# UNITED STATES PATENT AND TRADEMARK OFFICE

APPLICATION NO.	FILING DATE	FIRST NAMED INVENTOR	ATTORNEY DOCKET NO.	CONFIRMATION NO.
10/551,134	09/29/2005	Dennis Karlsson	95-725-P1791	4299

<b>Office Action Summary</b>	<b>Application No.</b>	<b>Applicant(s)</b>	
	10/551,134	KARLSSON, DENNIS	
	<b>Examiner</b>	<b>Art Unit</b>	
	Gunyoung T. Lee	2875

## **DETAILED ACTION**

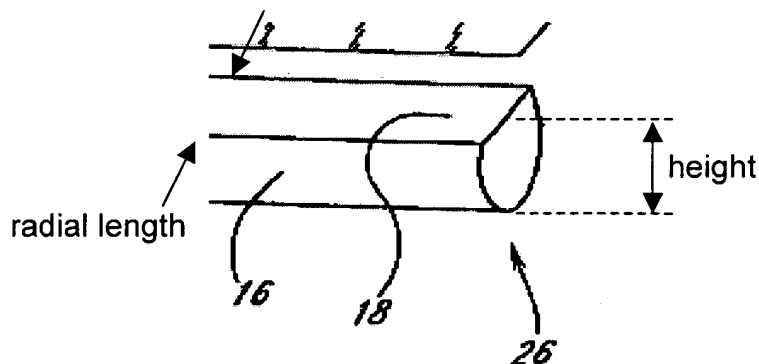
5. Claims 8-14, as best understood, are rejected under 35 U.S.C. 102(e) as being anticipated by Pelka et al. (US 6,637,924).
6. Pelka et al. disclose a lighting device having:

- The convex front side (16) is in direct communication with the rear side (18) (col. 10, lines 4-8);
- The convex front side (16) has a radius and a height (as shown in the following picture) being measured perpendicular to the rear side;

- The height is at least  $\frac{1}{4}$  of a radius length (as shown in the above picture) of the rear side (18);
- The front surface (16) extends between two opposing side surfaces (20, 22);
- The lighting guiding material (14) has a rod shape (Fig. 2); and
